# ADDITIONAL ROCKET 3 PDI & SERVICE CARE POINT

**TOL Ref. # 14204-SVC**

## Additional Rocket 3 PDI & Service Care Point

**1. Upper yoke pinch bolts**

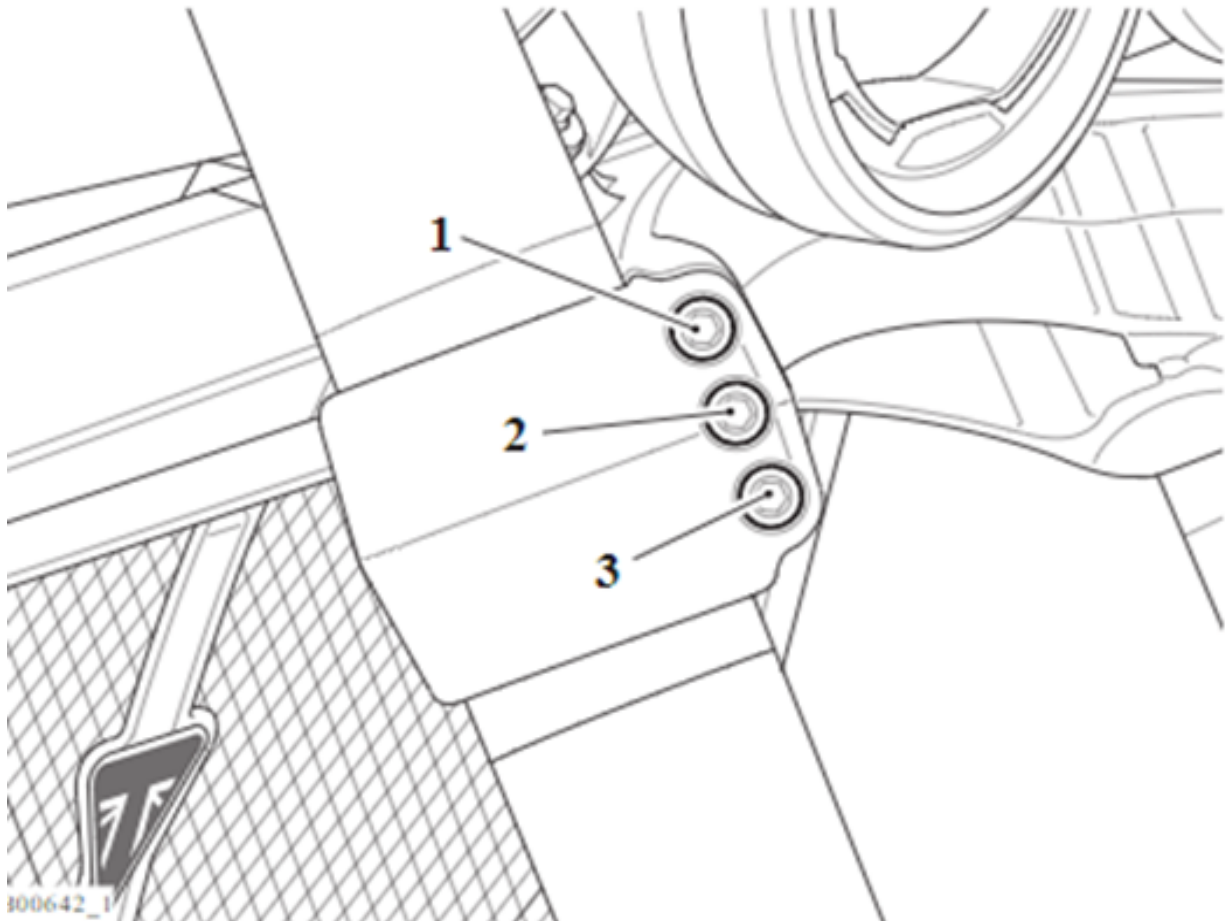
Triumph has identified an additional care point for all Rocket 3 model PDIs and first (600 mile/1,000 km) service inspections. The upper and lower yoke pinch bolts are required to be checked and – if necessary – re-torqued as specified in the service manual.

Tighten both left-side and right-side the upper yoke pinch bolts to **25 Nm**:
